Summary of Changes

This summary of changes is a synopsis of the NRC Requests for additional Information (RAI) and the FCS response to those requests. A detailed version of the response can be found in LIC-17-0047 that was submitted to the NRC on May 15, 2017. The NRC approved the Permanently Defueled Emergency Plan (PDEP) based on FCS response to the RAI's on December 12th, 2017 by Amendment No. 295 effective April 7, 2018 and this amendment shall be implemented within 90 days of the effective date. PORC approved the PDEP submitted to the NRC on December 16, 2016 and this summary only covers changes made since that time. NOTE: No changes were made to EP-FC-1001 Addendum 3 other than adding the procedure number to the top of each page. The content of EP-FC-1001 Addendum 3 remains the same as the initial submittal and was previously approved by PORC.

**PERMANENTLY DEFUELED
EMERGENCY PLAN
FOR FORT CALHOUN STATION**

FIGURE 2.1
On-Shift and Emergency Response Organization

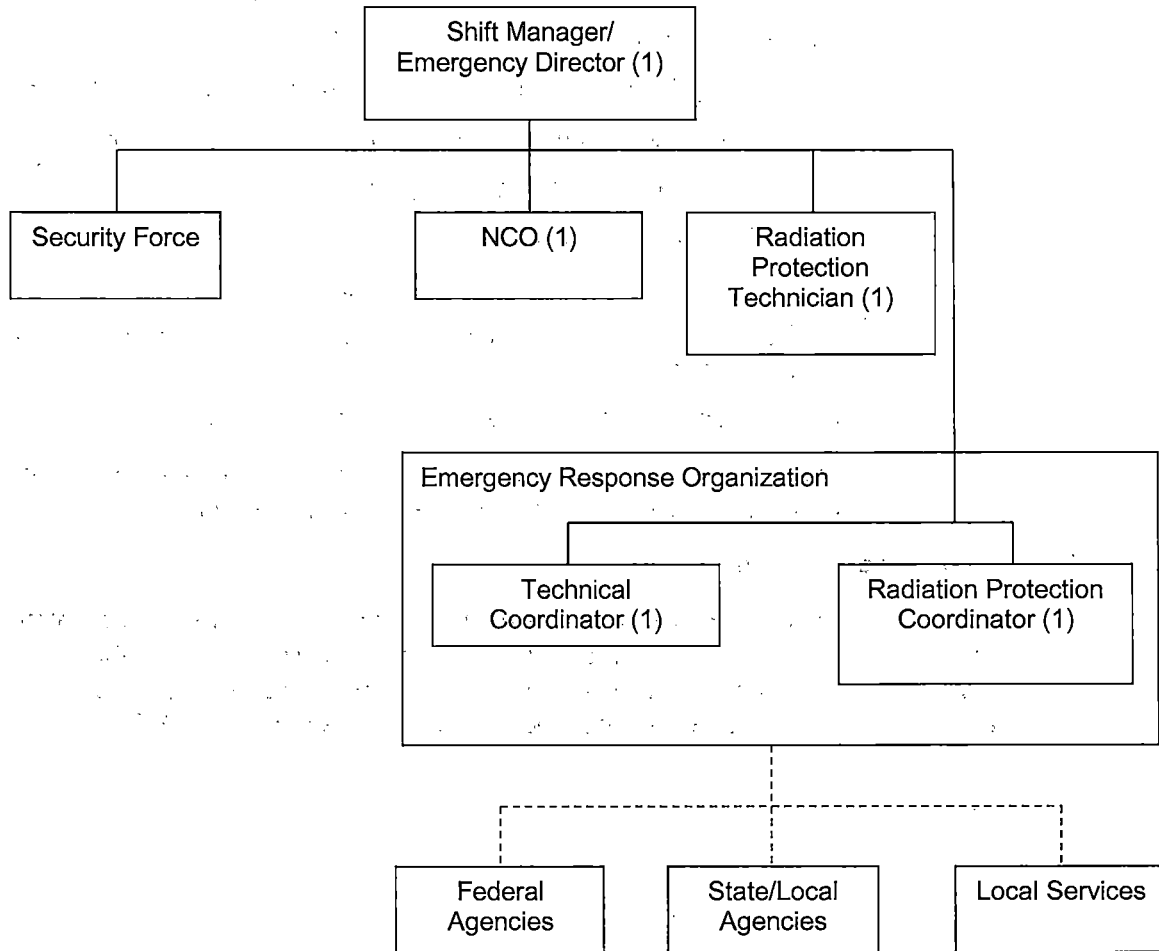
(NRC) FCS-RAI-5 – There is no reference to any personnel specifically assigned to perform SFP inventory makeup strategies in the proposed PDEP. Please explain who performs SFP inventory makeup strategies.

(NRC) FCS-RAI-13 - "Training for individuals assigned to licensee first aid teams shall include courses equivalent to Red Cross First Aid, CPR, AED for Lay Responders or equivalent." Please provide further information on who these personnel are on-shift (e.g., is duty performed as a collateral function), and what level and frequency of training they are given.

FCS Response: Table 2.1, “On-Shift and Emergency Response Organization Staffing Requirements,” includes an “*” next to the Non-Certified Operator (NCO), Shift Manager (SM), and the on-shift Radiation Protection Technician indicating these positions are on-shift personnel required to direct or perform site-specific mitigation strategies required for a catastrophic loss of SFP inventory.

FCS Response: Table 2.1 of the proposed PDEP has been revised to indicate that the first aid duties are assigned to on-shift personnel assigned other functions. Additionally, Section 15.0 of the proposed PDEP has been revised to include a section on first aid training (new Section 15.1.4). **Reviewer Note:** Updates in First Aid Training approved in Rev 3 of EP-FC-1001 were also incorporated into this procedure change and was previously approved by PORC.
